Access Compliance Report

Public Rights-of-Way

(Curb Ramps)

Intersection ID: 27494	Main Street: BALLANTYNE COMMONS PY	Cross Street: SUMMIT COMMONS BV	Location: S
ADA ID: 6BC3D25B2665	Ramp Type: Perp	Initial Pass/Fail: Fail	Overall Compliance: No
Severity Score: 22.5			
Codes/Mitigation Info/Possible Solution		Field Measurements/Component Compliance

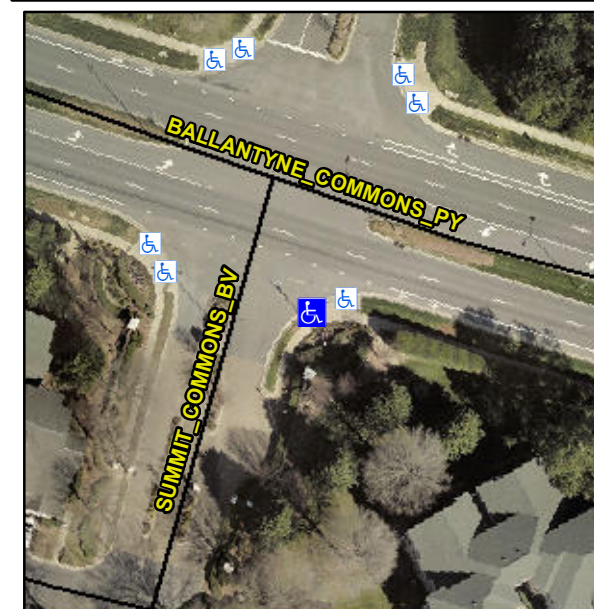
Not Found, R304.5.1, R304.2.2, R304.5.3

Compliance	Description	Data	Compliance	Description	Data
N/A	Ramp Length (in)	106.0	No	Ramp Slope (%)	8.4
No	Ramp Width (in)	42.0	No	Ramp XSlope (%)	2.2
N/A	Flare Type LT	N/A	N/A	Flare Type RT	N/A
N/A	Flare Slope LT (%)	N/A	N/A	Flare Slope RT (%)	N/A
N/A	Flare Traversable LT?	N/A	N/A	Flare Traversable RT?	N/A
N/A	Landing Length (in)	N/A	N/A	DWS Provided?	N/A
N/A	Landing Width (in)	N/A	N/A	DWS Contrast?	N/A
N/A	Landing Slope (%)	N/A	N/A	DWS Length (in)	N/A
N/A	Landing X Slope (%)	N/A	N/A	DWS Full Width?	N/A
N/A	Landing Curb? (Y/N)	N/A	N/A	DWS Offset (in)	N/A
N/A	Shared Landing?	N/A			
N/A	Gutter Ponding?	N/A	N/A	Gutter Slope (%)	N/A
N/A	Gutter Lip Ht (in)	N/A	N/A	Gutter X Slope (%)	N/A
N/A	Painted X Walk1?	No	N/A	Painted X Walk2?	N/A
	X Walk 1 Direction	To NW		X Walk 2 Direction	N/A
N/A	X Walk 1 Width (in)	N/A	N/A	X Walk 2 Width (in)	N/A
	X Walk 1 Slope (%)	5.4		X Walk 2 Slope (%)	N/A
	X Walk 1 X Slope (%)	1.0		X Walk 2 X Slope (%)	N/A

Remove & Replace Entire Ramp.
